ADDENDUM 1 : AMENDMENT/CLARIFICATION & EXTENSION OF CLOSING DATE

RE: TENDER FOR SUPPLY & DELIVERY OF RIG BRIDLE LINES FOR BARINGO SILALI GEOTHERMAL PROJECT. TENDER NO. GDC/DO/OT/014/2022:2023

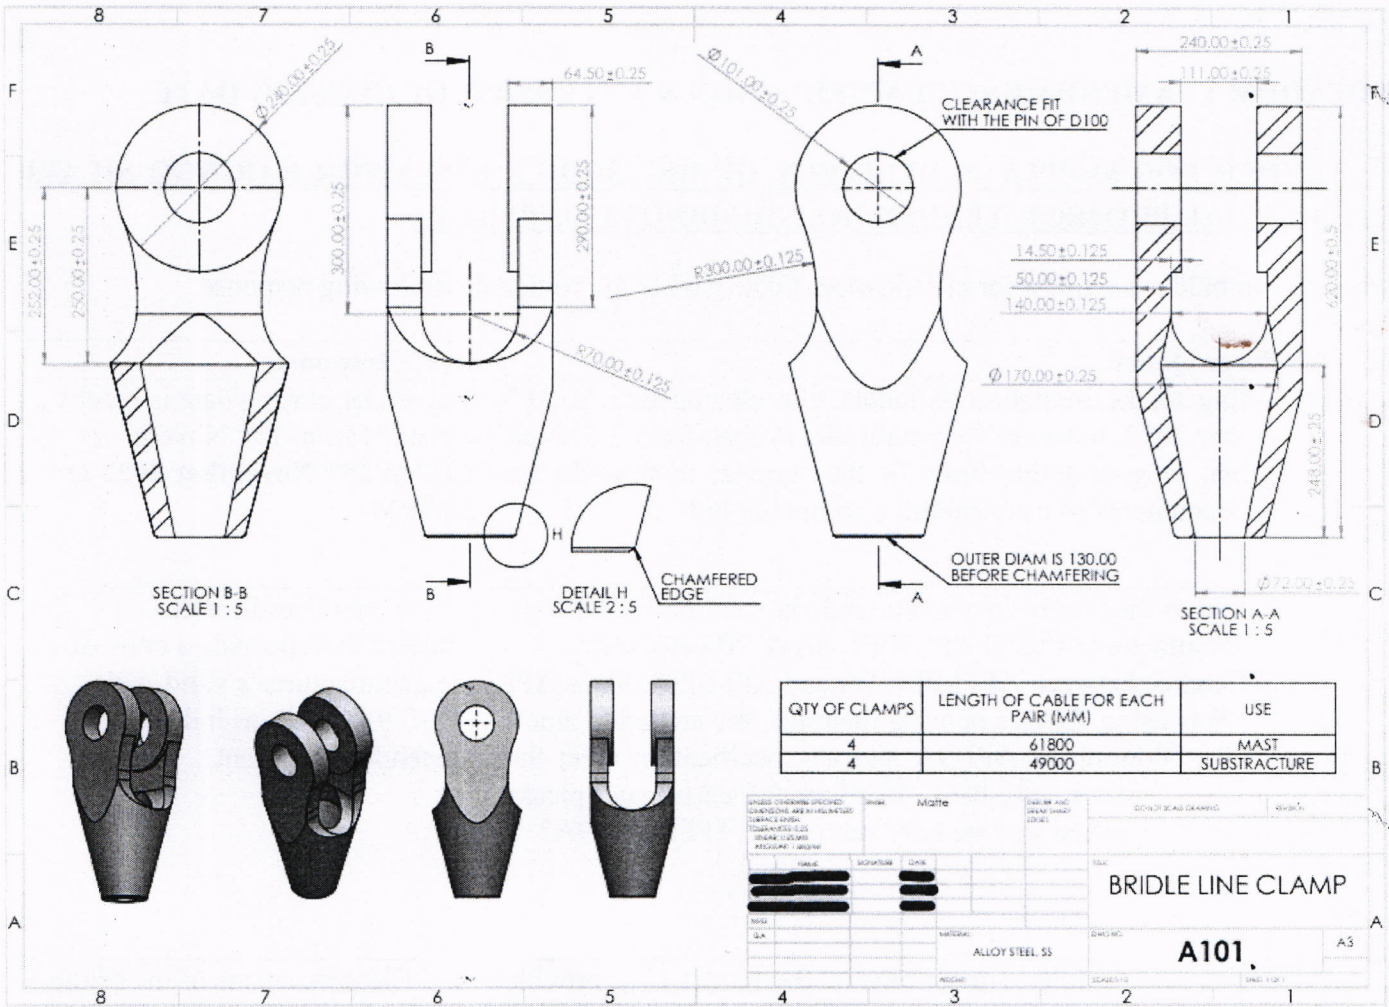
2.	According to schedule of requirements the bidder is to provide drawings for the goods to be supplied. However, a drawings featuring all the critical dimension for open speltor socket is crucial to enable us get the exact match. Therefore, we are kindly requesting for drawings for the speltor sockets with all the critical dimension.	<p>a. The dimensions of the bridle line are as per the attached drawing.</p> <p>b. The length of the cable remains as described in the tender document.</p> <p>c. Length measurements are from the center of the pin hole to the other center of the pin hole.</p> <p>d. The cable will be delivered together with its pins</p>
